Access Compliance Report

Public Rights-of-Way

(Curb Ramps)

Intersection ID: 30572	Main Street: ARBOR_TREE_LN	Cross Street: HAMILTON_GREEN_DR	Location: NW
ADA ID: 5719147D6A67	Ramp Type: BlendTrans1	Initial Pass/Fail: Fail	Overall Compliance: No
		Severity Score: 12.5

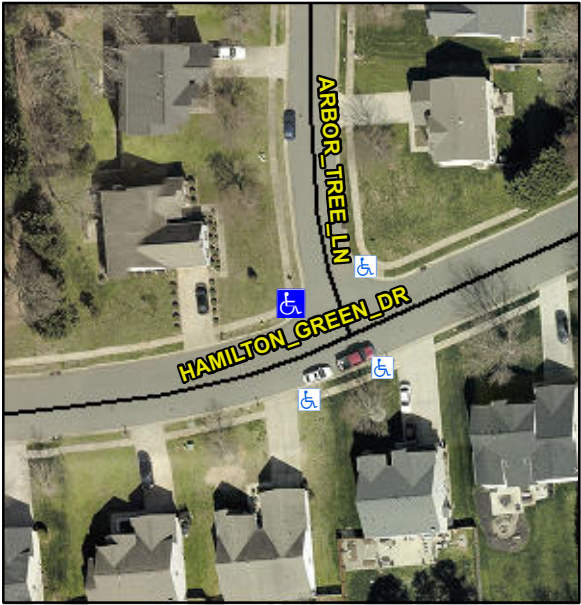
Codes/Mitigation Info/Possible Solution			Field Measurements/Component Compliance			
	Possible Solutions:		Compliance	Description	Data	
	Remove & Replace Curb Ramp With Two New Directional Ramps or Equivalent.		N/A	Ramp Length (in)	52.0	Yes
			Yes	Ramp Width (in)	48.0	No
			N/A	Flare Type LT	N/A	N/A
			N/A	Flare Slope LT (%)	N/A	N/A
			N/A	Flare Traversable LT?	N/A	N/A
			N/A	Landing Length (in)	N/A	N/A
			N/A	Landing Width (in)	N/A	N/A
			N/A	Landing Slope (%)	N/A	N/A
			N/A	Landing X Slope (%)	N/A	N/A
<p>Surveyor Notes:</p> <p>N/A</p> <p>PROW/ADA:</p> <p>R304.5.3</p>			N/A	Flare Type RT	N/A	N/A
			N/A	Flare Slope RT (%)	N/A	N/A
			N/A	Flare Traversable RT?	N/A	N/A
			N/A	DWS Provided?	N/A	N/A
			N/A	DWS Contrast?	N/A	N/A
			N/A	DWS Length (in)	N/A	N/A
			N/A	DWS Full Width?	N/A	N/A
			N/A	DWS Offset (in)	N/A	N/A
			N/A	Gutter Ponding?	N/A	N/A
			N/A	Gutter Lip Ht (in)	N/A	N/A
<p>Total Cost:</p> <p>\$ 3200.00</p>			N/A	Painted X Walk1?	No	N/A

X Walk 1 Direction	To S	
				X Walk 1 Width (in)	N/A	
				X Walk 1 Slope (%)	4.3	
				X Walk 1 X Slope (%)	5.3	
			N/A	Ramp inside XWalk1?	N/A	N/A
				Road Slope (%)	3.8	
				Road X Slope (%)	5.1	N/A
			N/A	Any Obstructions?	N/A	N/A
				Obstruction Type		
					N/A	N/A
					Yes	Surface Condition? (G/P)
					N/A	Curb Slope (%)
						Good
